SUNDRY NOTICES AND REPORTS ON WELLS
Do not use this form for proposals to drill or abandon a well. Use form 3160-3 (APD) for such proposals.

8. Well Name and No.
H B 10 FEDERAL 1

9. API Well No.
30-015-29157-00-S1

**** BLM REVISED ** BLM REVISED ** BLM REVISED ** BLM REVISED ** BLM REVISED ****

CURRENT WELLBORE

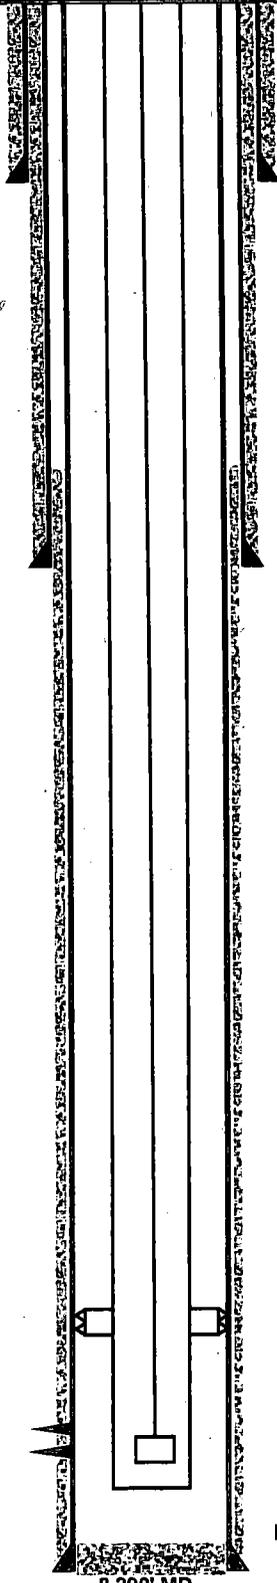
- MIRU P&A Unit. Retrieve rod pump assembly and 2-7/8" production tubing from 7,960'.
- Set CIBP @ ~~7,850'~~ ⁷⁸³⁰. Tag. Circulate w/10# salt gel mud.
- Spot 25 sx (200') CI H @ 7,950' - 7,650'. ^{7830-7630 (50-100' above upper Acifs)}
- Spot 25 sx (250') CI C @ ~~6,820' - 6,570'~~ ⁶⁸⁷⁰⁻⁶⁶²⁰. Tag. (Bone Spring @ 6,819')
- Spot 25 sx (250') CI C @ 3,570' - 3,320'. (3000' spacer plug)
- Spot 30 sx (300') CI C @ 3,100' - 2,800'. Tag. (Delaware @ 3,062'; B.Salt @ 2,852')
- Perf 5-1/2" casing @ 4,160'. Pump 40 sx CI C (170') in/out @ 1,160' - 990'. Tag. (T.Salt @ 1,162') ⁹⁶²
- Perf 5-1/2" casing @ 405'. Pump 95 sx CI C in/out to surface. (13-3/8" shoe @ 355') ¹⁰¹⁵
- Cut wellhead off 3' bgl. Set dry hole marker.
